RE: License No. SUA-1470
Docket No. 40-8902

Enclosed is the response to Question Number 5 contained in your May 30, 1990 letter regarding ARCO Coal Company's March 1990 Reclamation Plan. This response concludes ARCO's response to the fourteen (14) NRC questions related to the technical aspects of the Plan.

**ARCO COAL COMPANY
1990 RECLAMATION PLAN
RESPONSES TO NRC QUESTIONS**

Date:	Scale:	Figure
		5.1-1

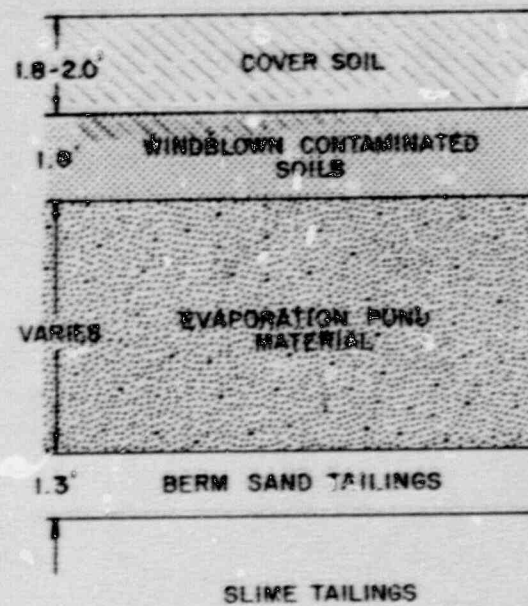
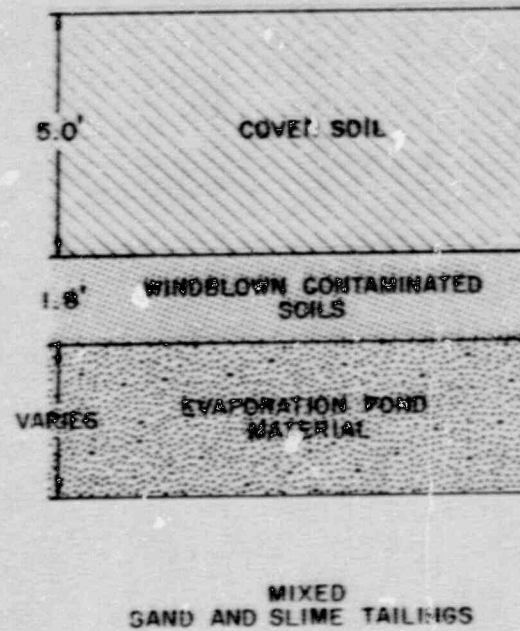
- Question 5 The February 1990, cover thickness analyses submitted in your March 21, 1990, plan are substantially different from the cover thickness analyses previously submitted. The most significant differences are in the physical property parameters for the slimes portion of the tailings data. Your consultants' February 1990, report does not provide sufficient justification as to why these parameters were changed. As the changes that were made are not conservative, additional information will be required before NRC can concur in designs. Please provide a more detailed assessment of why changes were made in the physical properties applied in the models.

- Response 5 The change from the 5.2-foot radon cover thickness in the 1986 Reclamation Plan to the 1.7-foot thickness contained in the March 1990 Plan, is due to the layering of berm sand tailings, evaporation pond residues, and windblown tailings-contaminated soils as fill on the slime tailings area. The layered fill is described in detail in the current plan. The fill serves as an effective means for attenuating the radon flux from the slime tailings using other, less contaminated materials. The result is that the radon attenuation afforded by the fill materials reduces the amount of clean radon barrier borrow needed to complete the attenuation of the radon flux to the 20 pCi/m²/sec design requirement.

Your observation that the physical properties used for the slime tailings differ between the previous submittal and the current plan is correct. However, those changes were not influential in regard to the dramatic reduction of the radon barrier thickness. That reduction was due to the layered fill, as discussed above. To demonstrate that this is the case, we have rerun the RAECOM model using the old physical properties for the slime tailings. The area-weighted radon barrier thickness that results is 1.8 feet, assuming the same layered fill above the slime. Thus, the layered fill accounts for 3.4 feet of the cover thickness reduction, while the changes to the physical properties account for 0.1 foot of the reduction. Table 1 summarizes the two sets of physical properties assumed for the slime tailings for easy comparison.

Since both the 1.7-foot and the 1.8-foot radon barrier thicknesses fall within the 2-foot thickness planned for constructability, the actual impact of the changes to the tailings physical properties is insignificant. We will agree with your review of the slimes cover and will use the more conservative physical properties (the original values). The radon cover over the slimes will be between 1.8 and 2.0 feet. Enclosed is the revised Figure 5.4-1 and Page 23 to be included in the 1990 Reclamation Plan. Also attached is Table 5.4-2 and Table 5.4-2A which give the revised cover thickness requirements using
